Lewis Wind Power EIS a critical review

**Lewis Wind Power (LWP) Environmental Impact
Statements (EIS) 2004 and 2006 - A Critical
Review**

R A Lindsay and J Freeman

March 2008

Figure 22. UEL-derived peat depths in vicinity of Turbine G54.

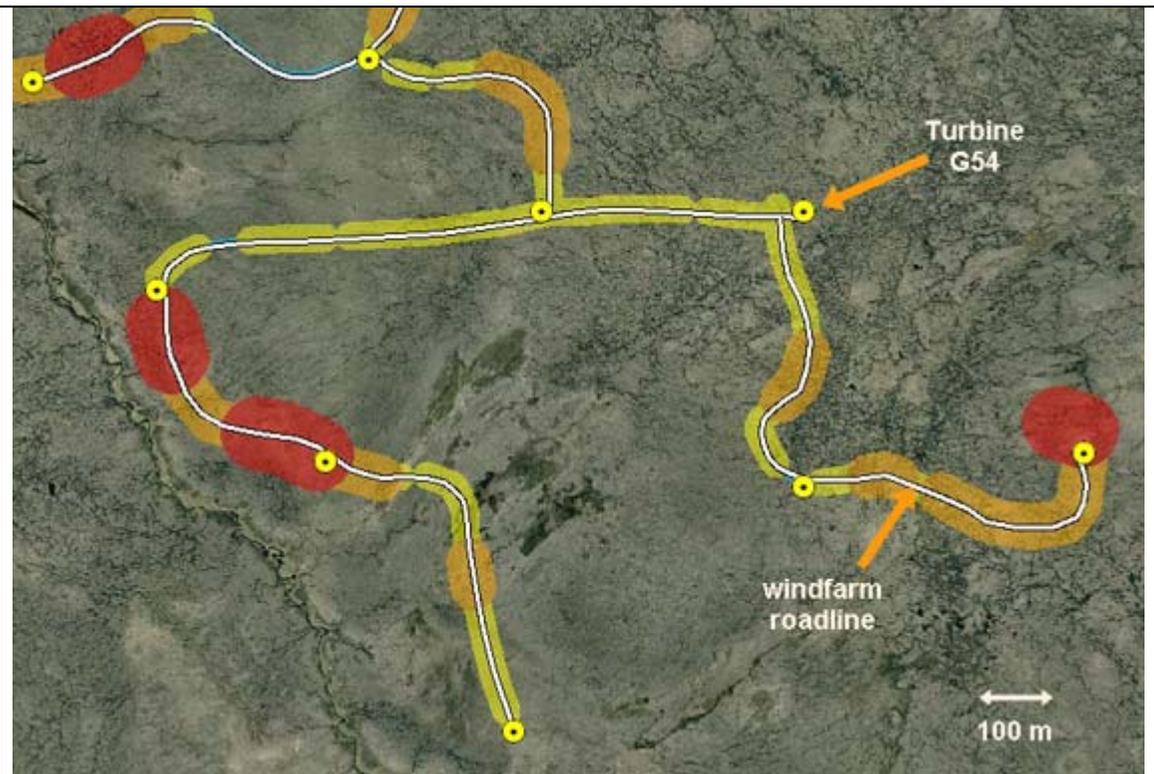
Despite these difficulties, a digital dataset based on the LWP road-line data was eventually generated by the UEL Peatland Research Unit. This derived dataset forms the basis of much that follows in the remainder of the present report (thus emphasising the core nature of this information). The data are displayed in Figure 21 below. It is evident from Figure 21 that, because the development area is so large, a map showing the whole development area cannot give any more than a general picture of peat-depth distribution. However, a more detailed view for a single portion of the development (Figure 22) shows how such data can be displayed in an informative way.

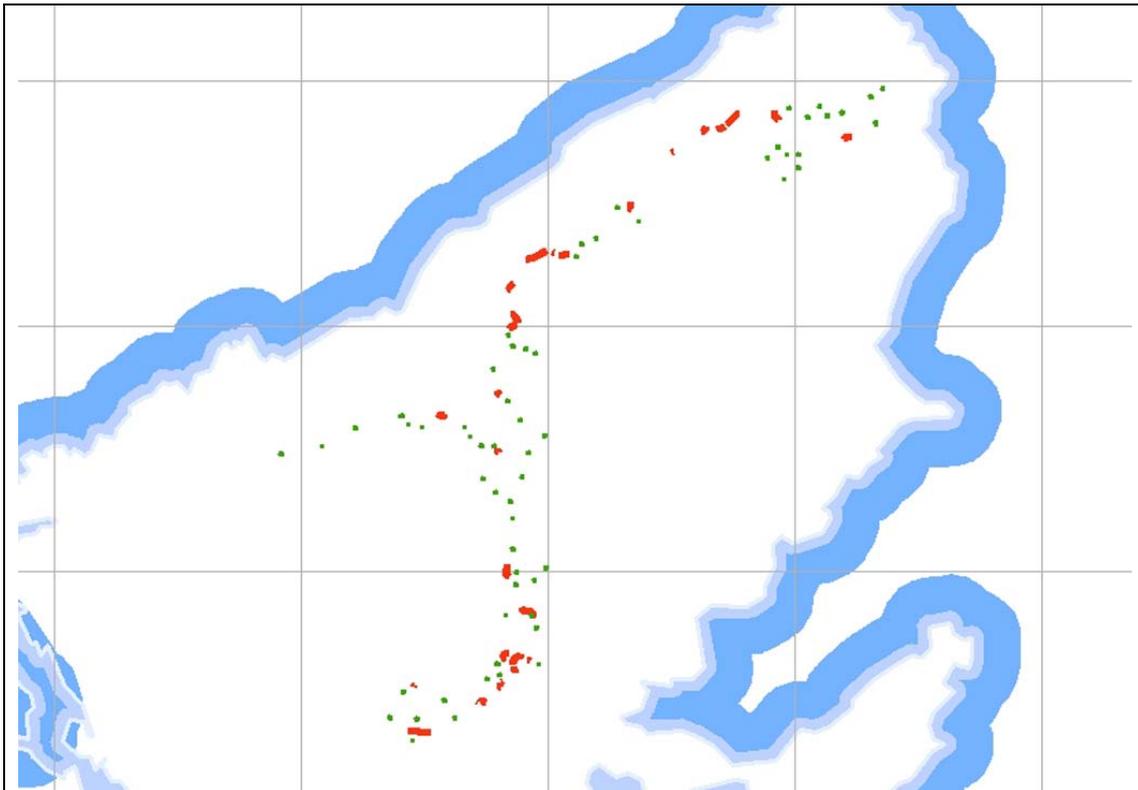
This information-gap is not trivial. It amounts to a total of 10.5 km, which represents some 7.5% of the whole road network. Add to this the sections of the development where the peat-depth data are not visible on [LWP 2004 EIS, Vol.4, Chapter 10, Figs.10.3a-d](#), which amount to a further 3 km, and the total length over which it is not possible to comment, or make impact judgements, amounts to 13.5 km, which represents 10% of the total road and turbine network (see Figure 23).

The absence of any such depth data for a set of infrastructure that will extend across 32.5 km of mainly peatland habitat ([LWP 2005 TLA, Non-Technical Summary](#)), represents a very considerable failing on the part of the LWP EIS documents.

Figure 26. Catchment line cutting through watershed mire system. Aerial photograph of watershed pool system at NB 441566, with catchment boundary (dark blue line) cutting through the bog pool system. The catchment line separates LWP Catchments 10 and 11.

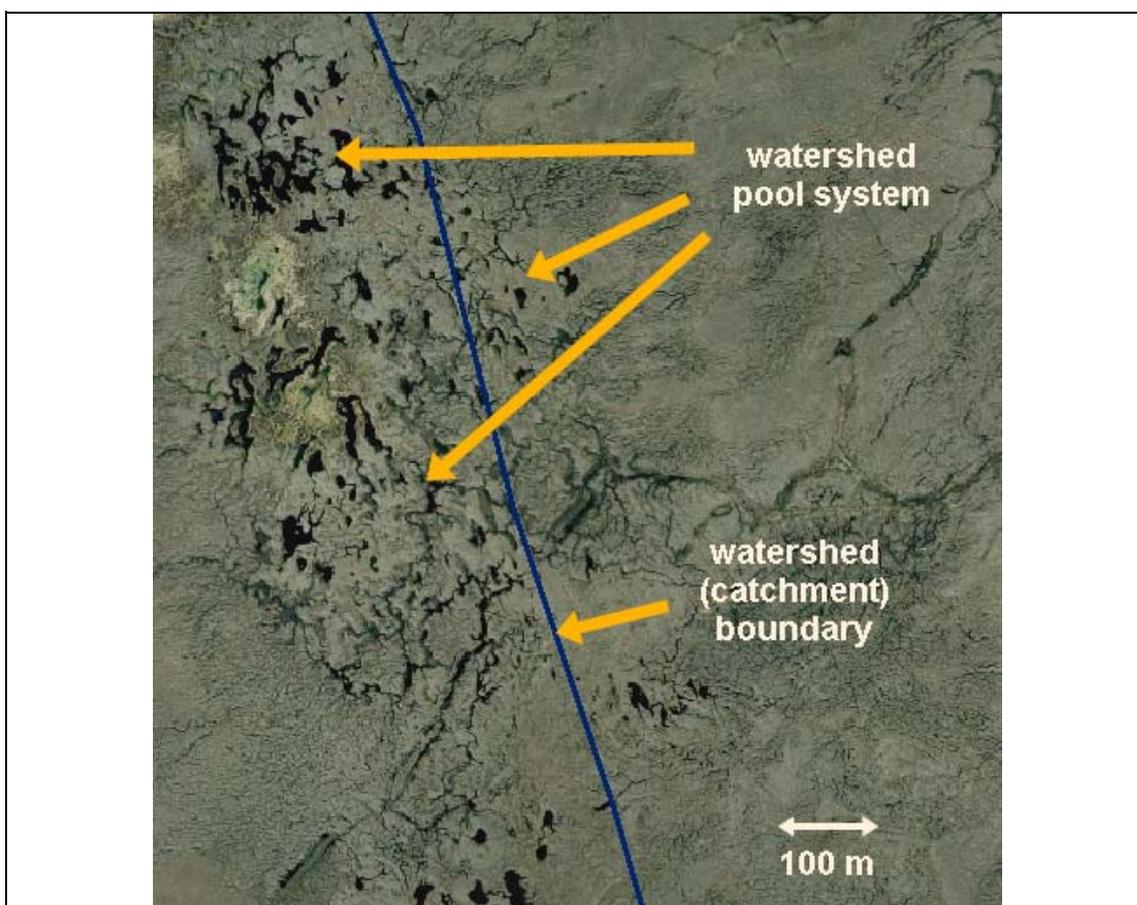
A typical example of the problem can be seen in Figure 26, where the boundaries of LWP Catchments 10 and 11 cut through a very evident watershed pool system. It is extremely difficult to provide an integrated picture of risk management or impact assessment when the core functional entity (*i.e.* the watershed bog pool system) is thus divided into portions. Looked at another way, if something bad happens to this single watershed pool system, the fish in *both* Catchments 10 and 11 will suffer.

'Catchment' is therefore a concept with limited value when describing a watershed blanket mire such as that shown in Figure 26. The mire unit functions as a distinct hydro-morphological entity almost *despite* the catchment line. Consequently a different approach to classification and description is most usefully invoked when describing peat bog systems, particularly when dealing with extensive peatlands such as blanket mire landscapes.

Figure 28. Contrast between LWP catchments and UEL macrotopes.

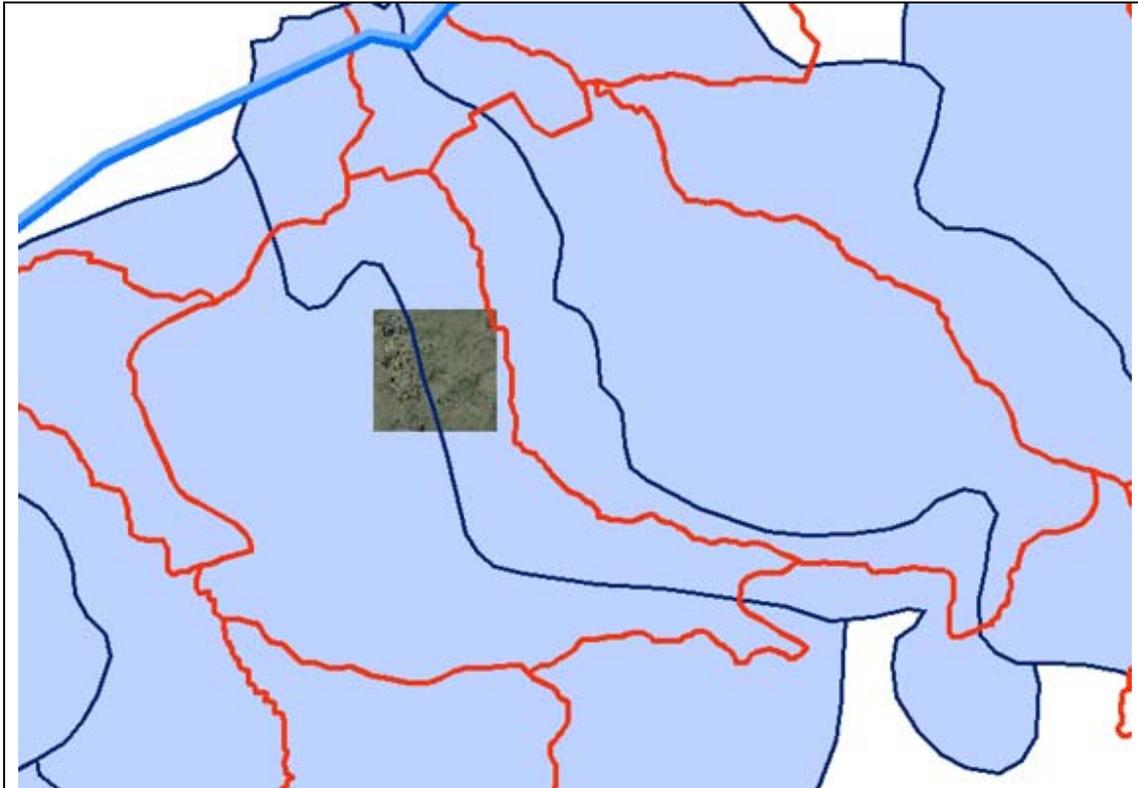
The inverse nature of the relationship between catchments and mesotopes can be seen in Figure 28, which displays the catchment boundaries defined by [LWP 2006 EIS, Vol.3, Chapter 10, Fig.10.4](#), together with a set of macrotope boundaries drawn up for Lewis by the UEL Peatland Research Unit.

The catchments drawn up by LWP (LWP 2006 EIS, Vol.3, Chapter 10, Fig.10.4) shown as pale blue shading with dark blue boundaries (the blue lines in top left are part of the coastline). Macrotope boundaries drawn up by the UEL Peatland Research Unit are shown in red. The aerial photograph of watershed pool system at NB 441566, and shown in Figure 26, is also displayed. Note the catchment boundary (dark blue line) cutting through the bog pool system shown in the photograph, and the way in which macrotope boundaries appear as the 'inverse' of catchment boundaries.

Figure 45. Mis-match between ladder fen and LWP Target Notes.

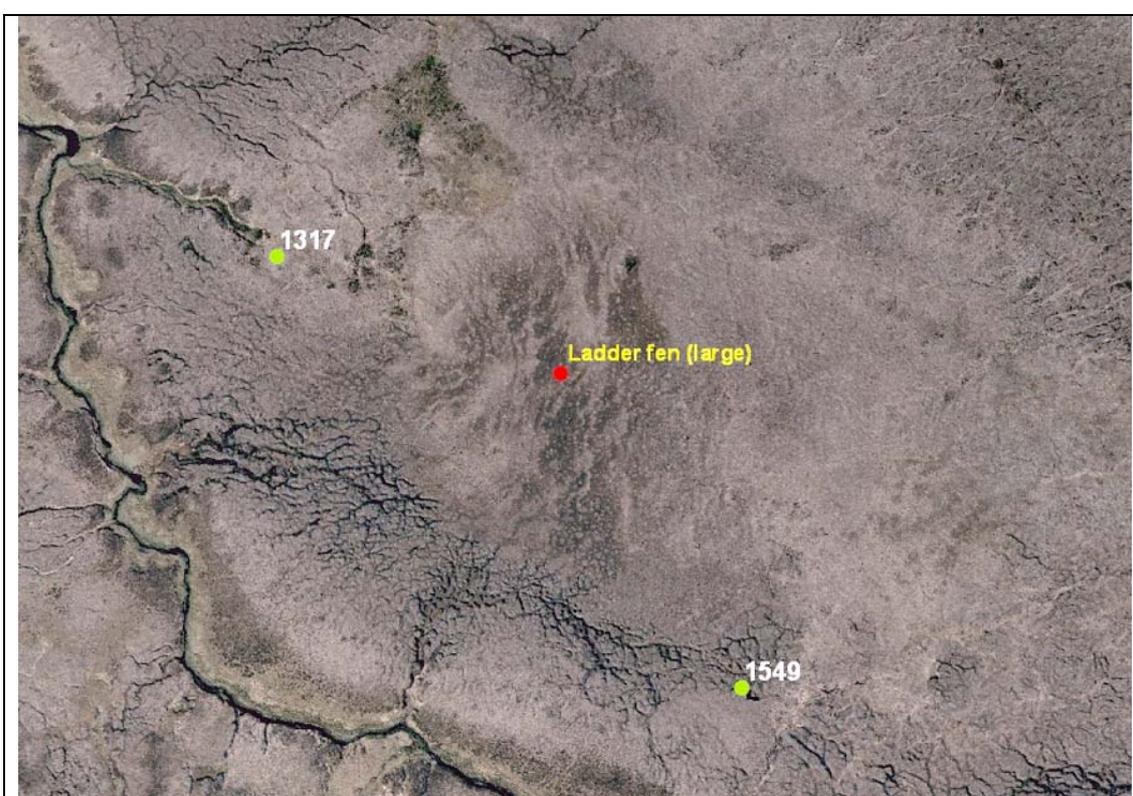
To take that final point first, because the LWP HSA survey informs all subsequent planning and actions for the LWP windfarm development proposal, it is possible to point to very evident ladder fens where the survey has not merely failed to note their presence, but has actually described the ground quite inappropriately. Thus in Figure 45 we can see that although there are two LWP target notes in the near- vicinity of the ladder fen shown in Figure 43, there is no target note for the ladder fen itself. What is particularly interesting is that the polygon as a whole, though curiously classed as Erosion Class 2, is also described as having a ‘rilled surface : common’. This matches entirely with the surface features of a ladder fen, although the only description provided, in [LWP 2006 EIS, Vol.5, Chapter 11, Appendix 11B, para 36](#), leaves things very ambiguous. Frustratingly, however, this category is never subsequently used in any part of the LWP EIS documents; it simply disappears.

Figure 49. Ladder fen with proposed windfarm infrastructure.

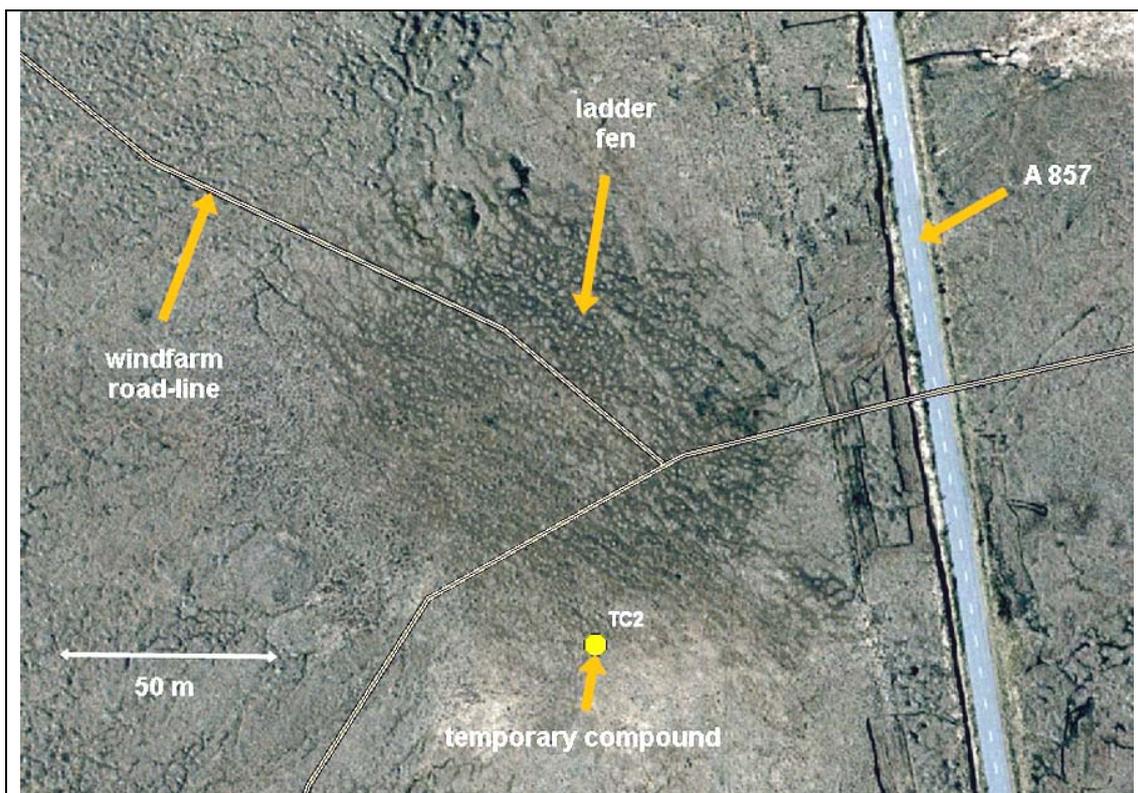
Given that (most of) the road-line and turbine bases were measured for their peat depth, it is a matter of some surprise that the particularly wet nature of these mesotope types was not picked up during the peat-depth survey. Nonetheless, as can be seen in Figure 49, parts of the proposed infrastructure have nevertheless been laid out as though such sites do not exist.

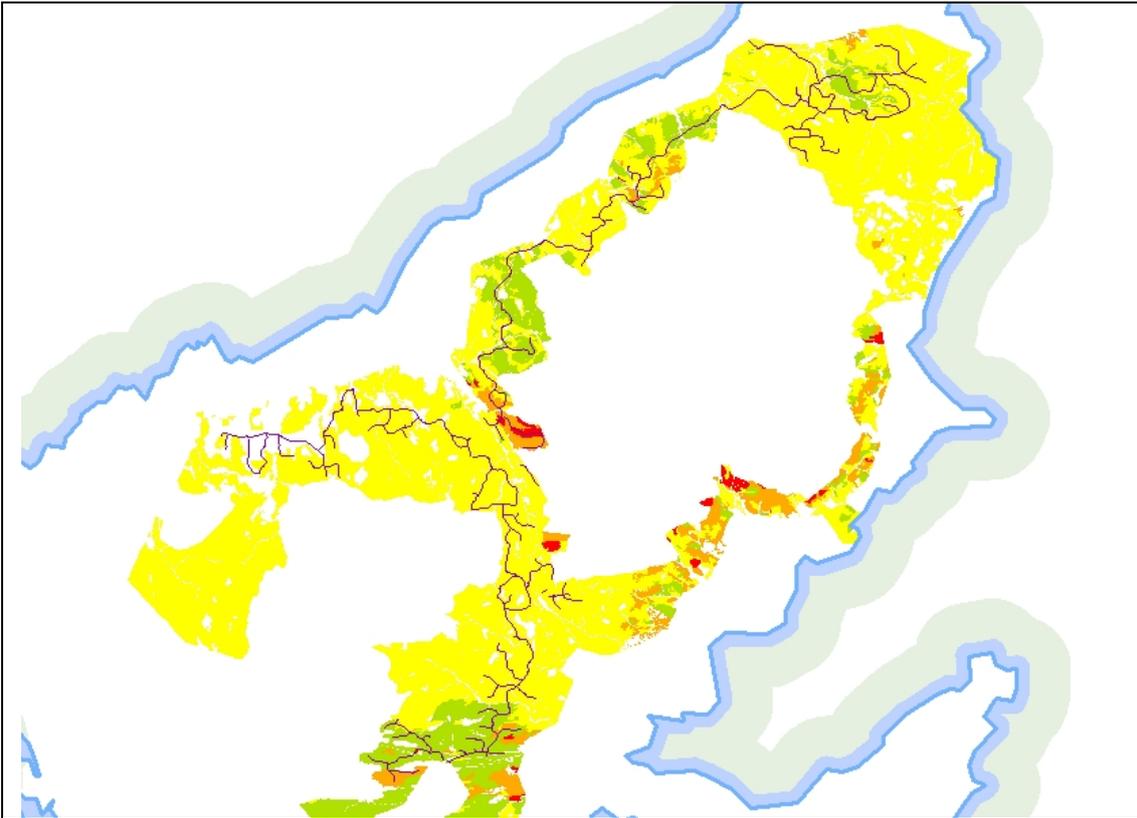
The resulting map of burning impacts is reproduced here as Figure 63, covering the revised area of the proposed LWP development. What is so striking about the map is the large area of ground recorded as showing no impact from burning. This does not tally well with description given by Goode and Lindsay (1979), the account of the Lewis peatlands produced by Everingham and Mayer (1991), an account of the peatlands of Harris by Averis and Averis (1995), nor the recent field survey and assessment undertaken by the UEL Peatland Research Unit.

Figure 65. Relationship between LWP HSA recorded fire intensity and surveyor.

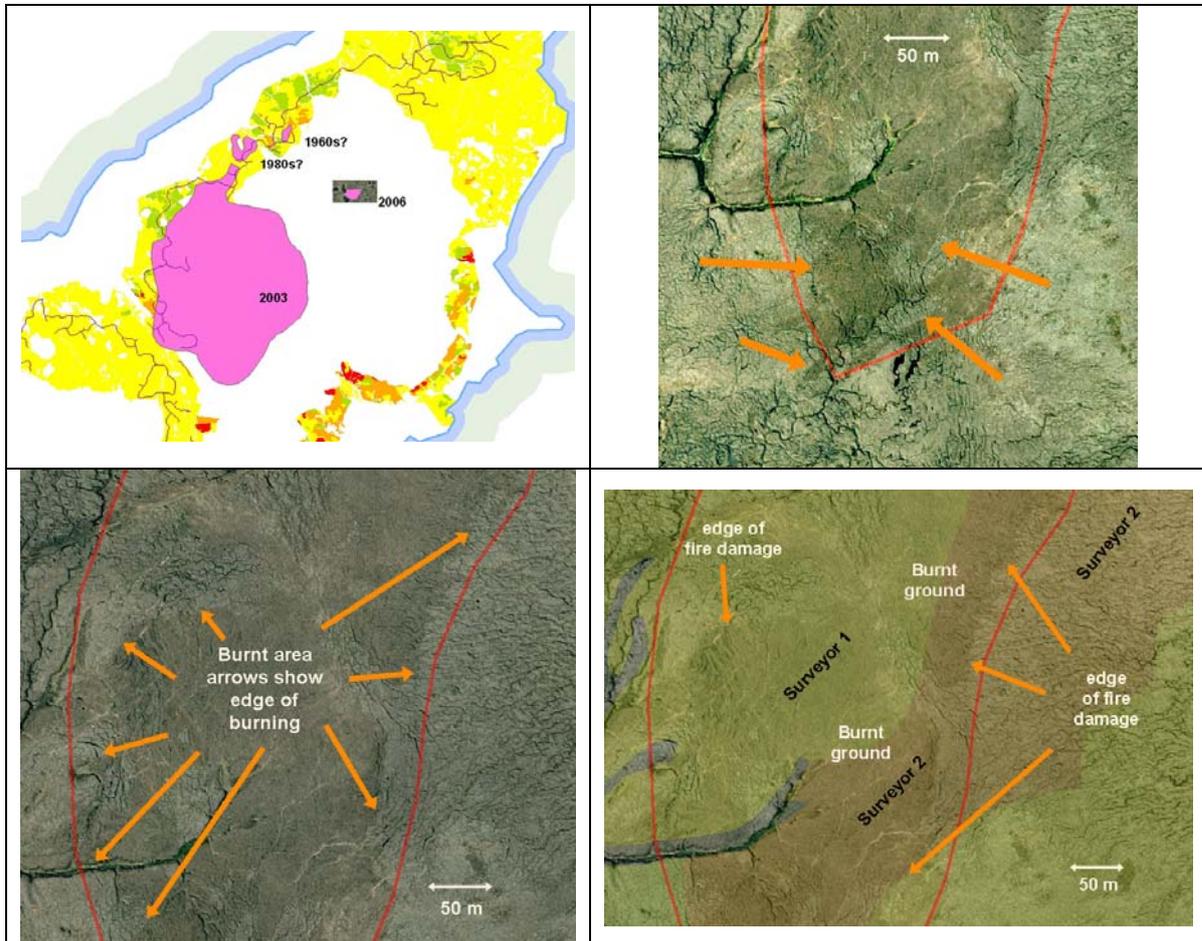
- did the LWP HSA survey in general significantly underestimate signs of burning? and/or
- do different perceptions of burning presence and intensity exist between surveyors within the LWP HSA survey team?

evidence of fire damage, while Surveyor 2 did not, across the same area of burnt ground. It is also worth noting that Surveyor 2, who did *not* record any burning impacts within this area, was the same surveyor who recorded 'no burning impact' for the area of the 1980s(?) fire.
